Item Name: Crosstube Fwd

DART AEROSPACE LTD	Work Order:	83062
Description: Crosstube High Fwd (205/212/412)	Part Number:	D212-664-101
Inspection Dwg: D212-664-141 Rev: D		Page 1 of 1

DRAWING NO. D212-664-141	TITLE XTUBE ASSY (205/212/412 HI FWD)	REV. D	DART AEROSPACE LTD ENGINEERING ORDER		D.E.O. NO. D212-664-141-D-1	SHEET NO. SHEET 1 OF 2	SCALE NTS
DRAWN	CHECKED	MFG. APPR.	APPROVED	DE APPR.	DATE	DATE	DATE
11.04.07	11.04.11	11.04.12	11/04/12	11.04.12	11.04.12	11.04.12	11.04.12

DRAWING NO. D212-664-141	TITLE CROSSTUBE ASS'Y (205 HI FWD)	REV. D	DART AEROSPACE LTD ENGINEERING ORDER		D.E.O. NO. D212-664-141-D-2	SHEET NO. SHEET 1 OF 1	SCALE NTS
DRAWN <i>UP</i>	CHECKED <i>ASS</i>	MFG. APPR. <i>AB</i>	APPROVED <i>MD</i>		DE APPR. <i>TH</i>		
DATE 11.07.15	DATE 11.07.20	DATE 11.07.21	DATE 11/07/21		DATE 11.07.21

D212-664-141/-141B
ASSEMBLY DETAIL

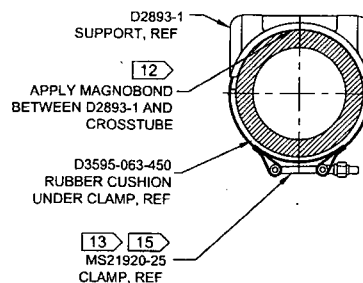
ADD AN INSPECTION WINDOW TO UNDERSIDE OF CROSSTUBE.

MASK AREA PRIOR TO PAINTING,
REMOVE MASKING AFTER PAINT
AND APPLY CLEAR COAT

- 2) FINISH: CHEMICAL CONVERSION COAT PER DART QSI 005 4.1
PRIME INSIDE AND OUTSIDE PER DART QSI 005 4.2
MASK UNDERSIDE OF CROSSTUBE AS SHOWN (HATCHED AREA) AND
PAINT OUTSIDE PER DART QSI 005 4.2
REMOVE MASKING AND APPLY CLEAR COAT

D212-664-501
BENDING AND DRILLING DETAIL

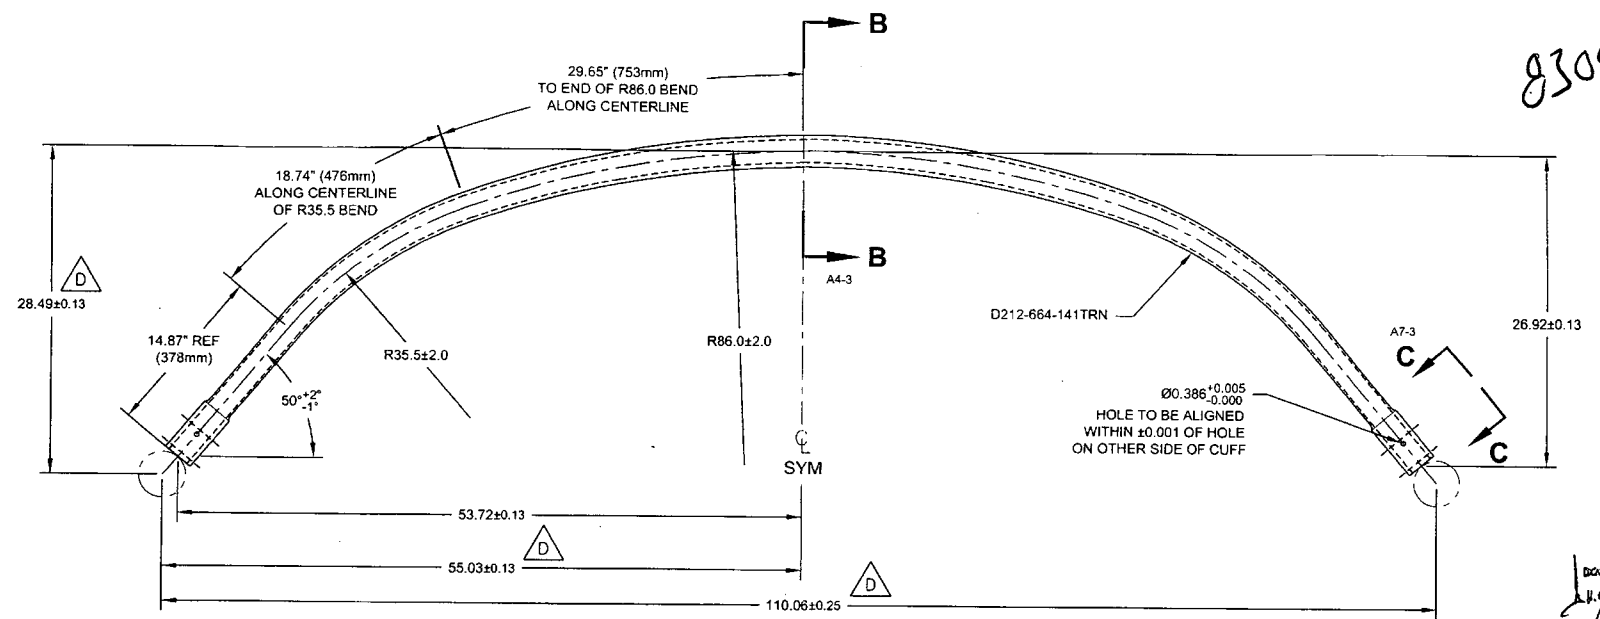
NCR: 12-1480		WORK ORDER NON-CONFORMANCE (NCR) JTB.63						
DATE	STEP	Description of NC Section A	Corrective Action Section B			Verification Section C	Approval Chief Eng	Approval QC Inspector
			Initial Chief Eng	Action Description Chief Eng	Sign & Date			
12.06.01	120	Tube overbent. Middle wasn't bent enough. All markings were removed all board due to damage after fire	AK 12/06/07 PSI 042	Width too narrow @ 06.86. Height is +0.51, too high for fwd tube. SCRAP 4P 12.06.07	Rm 12-6-4	JW 12-6-4	AK 12/06/07 PSI 042	reloc 04

Comments
Too narrow (2107) too high (+0.51).
SCRAP 4/12.06.01
